RESPONSE TO REQUEST FOR ADDITIONAL INFORMATION

APR1400 Design Certification

RAI No.: 402-8477
SRP Section: 10.04.01 – Main Condensers
Application Section: 10.4.1
Date of RAI Issue: 02/10/2016

Question No. 10.04.01-5

Figure 1 Turbine Generator Building Drain System

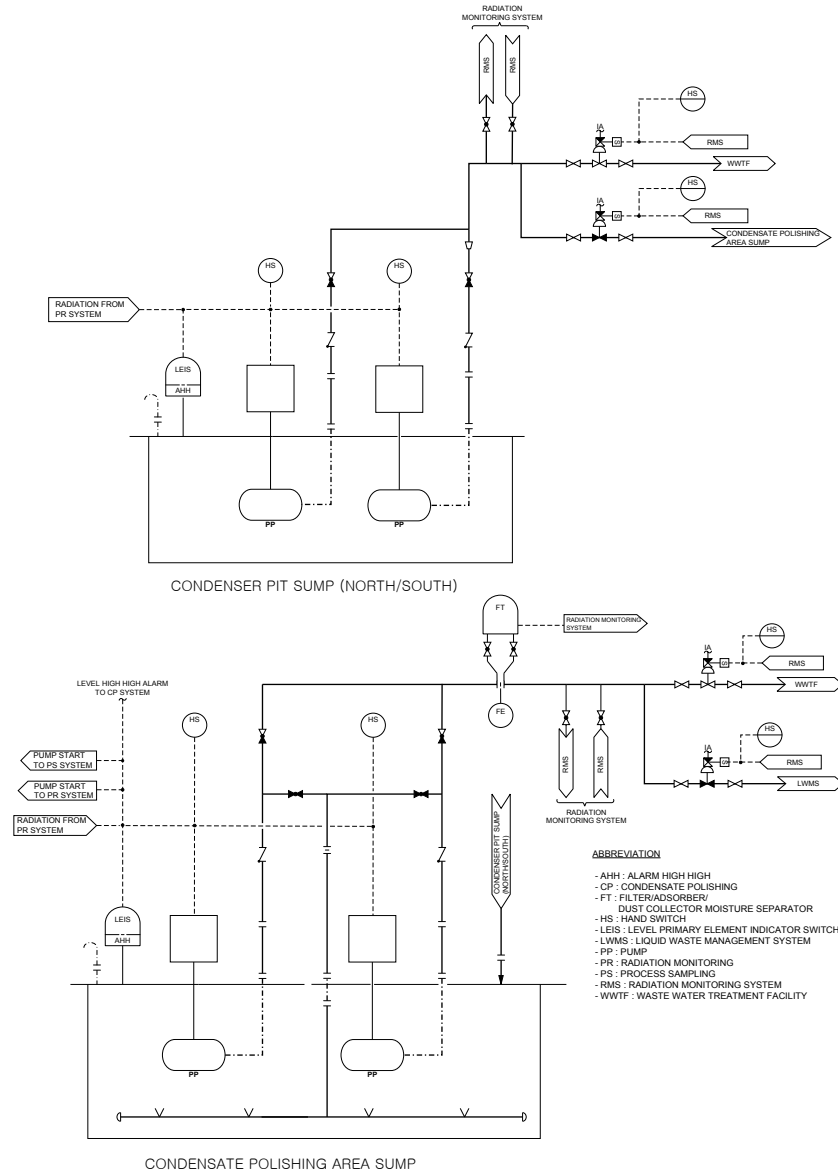
The applicant is requested to provide additional information in the DCD as related to the means on the controlled collection of waterbox drainage that may contain radioactive contaminants. The DCD should be revised to include location of the collection point(s) for where the water from the MC waterbox drains are collected and the radiation activity for drain collection is monitored.

The MC waterbox drains are collected into the condenser pit sumps (north/south), which are located in the turbine generator building through piping that is part of the equipment vents and drains system. The drains are monitored and controlled for process radiation through the condenser pit sumps and a condensate polishing area sump.

In addition, Figure 1 shows the interconnection of the turbine generator building sump pumps between the LWMS (Liquid Waste Management System) and the WWTF (Waste Water Treatment Facility). Additional information about the turbine drain system was provided in the response to Question No. 09.03.03-3 and 09.03.03-4.
